APPROVED MEETING MINUTES

December 18, 2014

The Whittaker Alley Vacation 4755 Fauntleroy Way SW

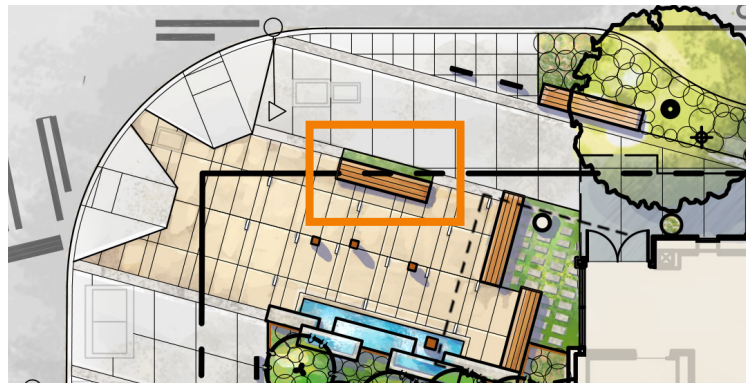
1. Reevaluate the placement of or consider removing the bench shown at right on the Fauntleroy Way SW side of the Gateway Plaza at SW Alaska St and Fauntleroy Way SW in order to allow easier passage through the plaza.

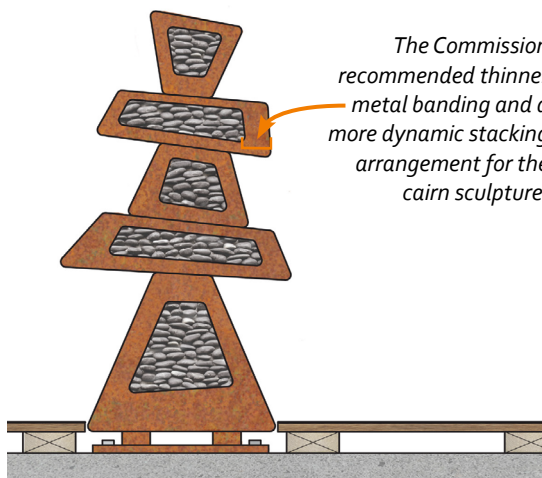
6. Reconsider the thickness of the metal banding on cairn piece, which feels excessive as currently designed. Consider the relationship of the stones within the cairn to the thickness of the banding.
7. Explore stacking the cairn pieces in a more dynamic way rather than in a flat plane.
8. Refine the edge detail where the wood slats meet the granite boulder for the "Passageway" sculpture to ensure the interface of these two materials is successful.
9. Ensure the sculptures at the corner of SW Edmunds St and Fauntleroy Way SW have the dimension and depth represented in plan, which is a more intriguing scale than what appears in the perspectives.

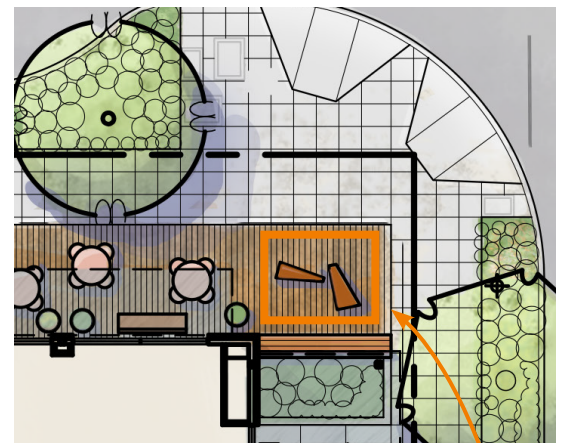
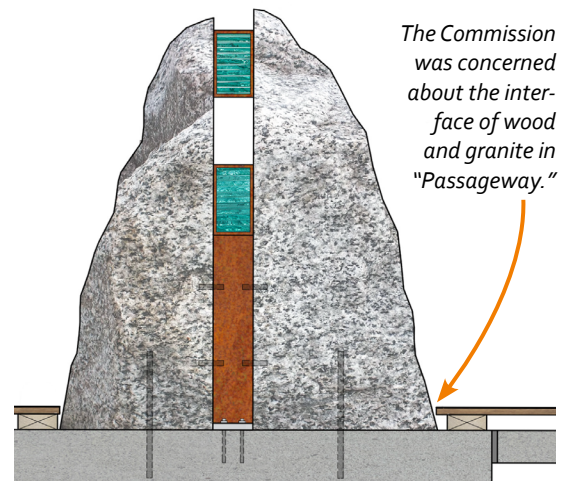
On the green wall, the Commission recommended eliminating the vines and suggested modifying the width of the metal screens adjacent to the plantings.

The Commission encouraged the artist to ensure that the sculptures at Edmunds and Fauntleroy would have the depth and scale shown in plan at right, which the perspectives to the left seem not to reflect.
